Bend-Redmond
Habitat
for Humanity®

Wilson Ave
Middle Income Pilot Grant

Chapter 1: Parking Areas				YES	NO	MAYBE	NOTES	HABITAT DIRECTION
1.1.1 Parking space width \geq 11 feet.	✓							
1.1.2 Parking space length \geq 20 feet.	✓

ENLARGED PLANS & INTERIOR ELEVATIONS

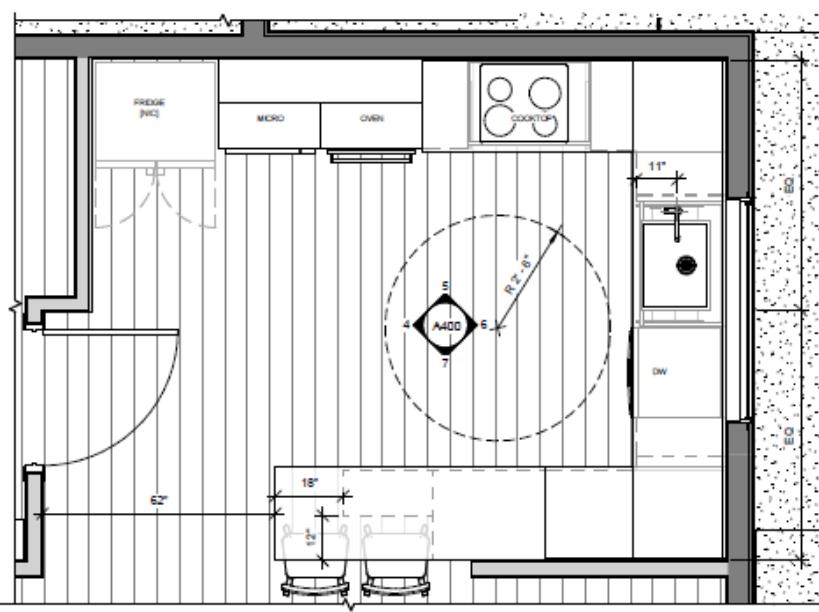
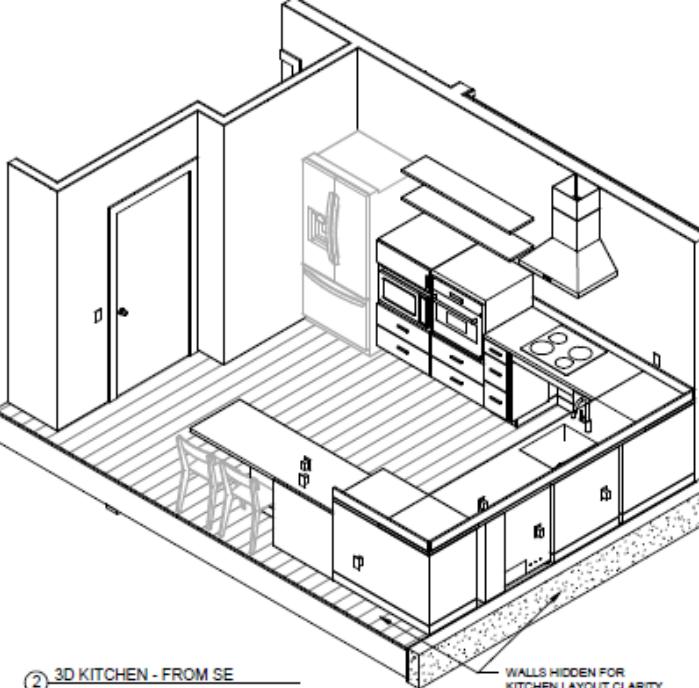
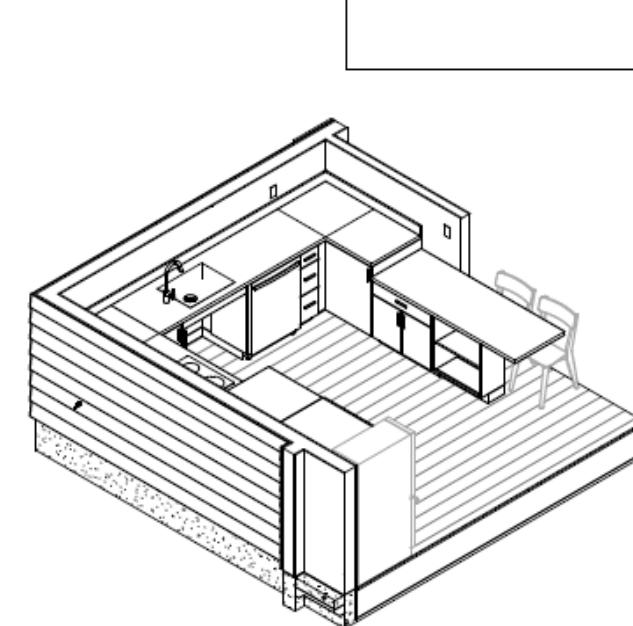
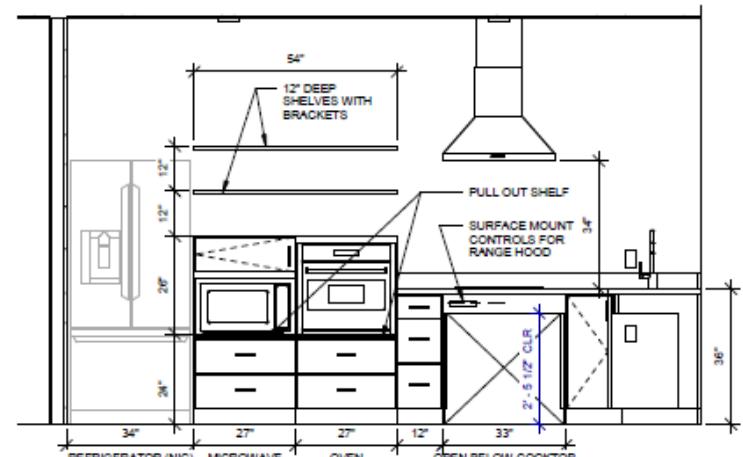
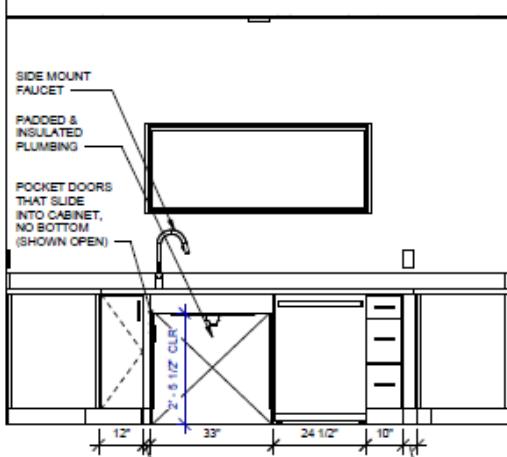
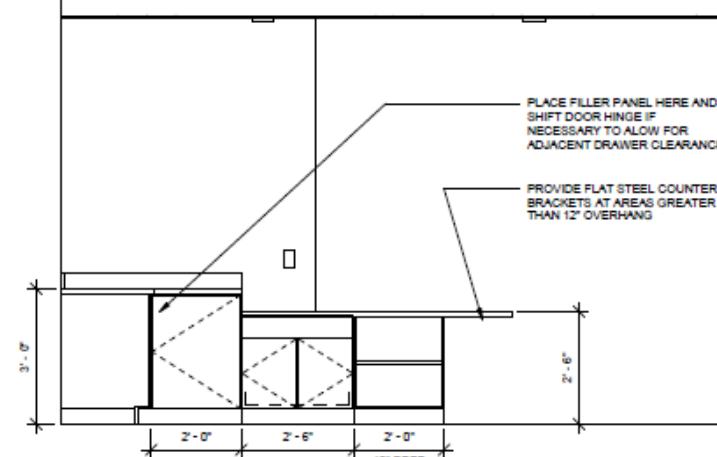
NOTE CONTROL LOCATION FOR RANGE HOOD.
[UD 5.3.7]

PULL OUT SHELVES UNDER OVEN AND MW.
[UD 5.3.10]

KNEE CLEARANCE BELOW COOKTOP AND SINK.
[UD 5.3.4]
